जनपद बागेश्वर के अन्तर्गत बालीघाट—धरमघर—खन्तोली पुल से गुरगुच्छा प्राप्ता० स्कूल तक मोटर मार्ग के निर्माण हेतु ०.६३ है० वन भूमि के प्रत्यावर्तन के सम्बन्ध में।  
(Online Proposal No- FP/UK/ROAD/12710/2015)

वन एवं पर्यावरण मंत्रालय भारत सरकार की आपत्ति के बिन्दु संख्या 1 के कम में  
आख्या

**Geological Site Assessment of 3.0 Km long Khitoli Bridge to Gurkucha Motor Road Alignment Corridor between CH 0.0-3.0 Km, Kapkot Block, District Bageshwar (Kumaon)**

Broader Satellite view of the Site

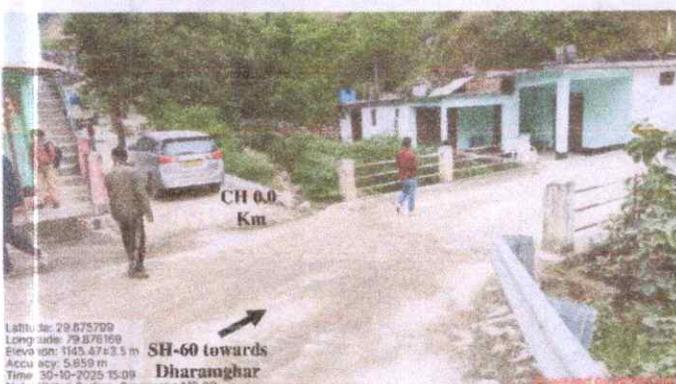
Location	Alignemnt-1 (White)	Alignemnt-2 (Blue)	Alignemnt-3 (Yellow)
Latitude	29° 52' 32.90"	29° 52' 33.00"	29° 52' 33.90"
Longitude	79° 52' 34.20"	79° 52' 34.75"	79° 51' 53.00"
Elevation	1160 m	1160 m	1140 m

#### View of alignment-1 site at CH 0.0 Km

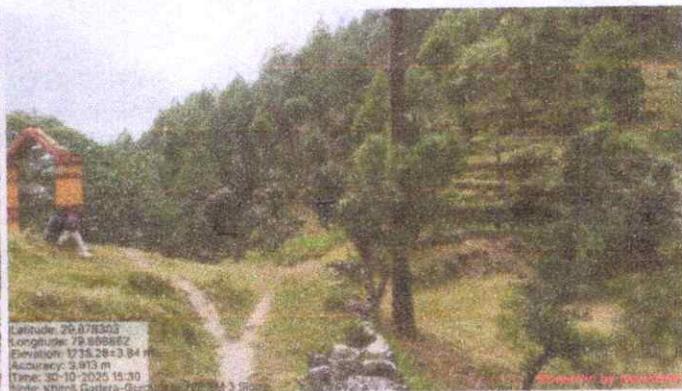
**Alignment-1** diverts from CH 59 Km of SH-60 near right abutment site of Khitoli motor bridge and is 3.0 Km in length, it does not have any hairpin bends and the gradient of this alignment is level to 1:20, 1:24 & 1:60 of rising gradient and 1:40 of falling gradient. This alignment has already been found geologically suitable by Mr. Vijay Dangwal (Ex. Senior Geologist) of PWD. Accept that the alignment intersects an old muck dumping zone (initial ~50 m) for which suitably designed protection measures are to be taken.

The hill slope of the alignment-1 site area is gentle to moderate to steep which declines at ~10-40° initially towards west direction followed by South-East & south-West direction. The approximate strength of exposed rock mass is around ~80-100 MPa and has undergone  $W_0$  to  $W_3$  weathering grade. The alignment-1 intersects 02 small perennial streams/naalas at Km 01 (~ CH 0.500 Km) & Km 02 which in the absence of scuppers/culverts/bridge may damage the motor road especially during monsoon season.

2. At places where the hill slope is steep and is covered with thick OB & SWM construction of suitably designed retaining wall/breast wall with proper weep holes is to be made sure on either sides of the motor road especially at initial ~50 m where the alignment intersects an old muck dumping zone.
